DOCUMENT CHANGE NOTICE (DCN)

DOCUMENT No. (DOC-REV-GP. ID)	TITLE	NEW REV.
D961421-A-D	Core Optic Component Carrier Base Plate	B
D961425-A-D	Core Optic Component Carrier Base Assembly	B
D961469-A-D	Core Optic Component Carrier Foot	B

D961469:

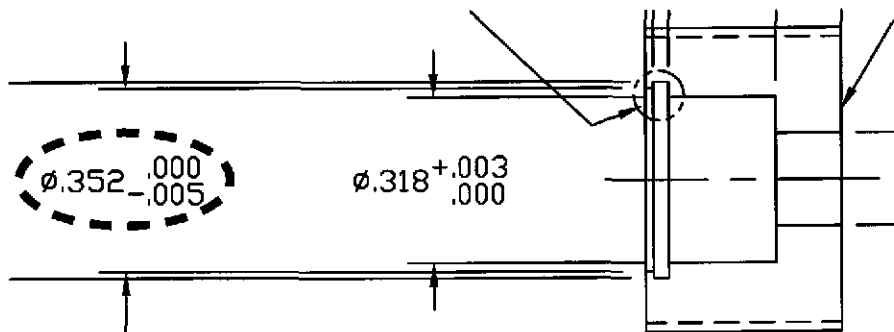
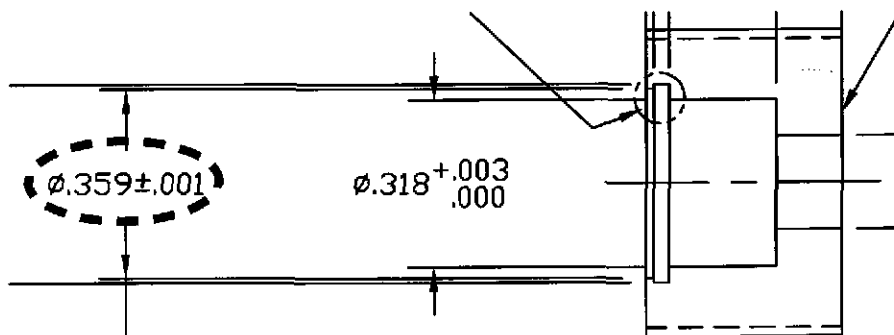
FROM:

TO:

D961469: Larger clearance hole needed for installation of snap ring on next assembly (D961418).
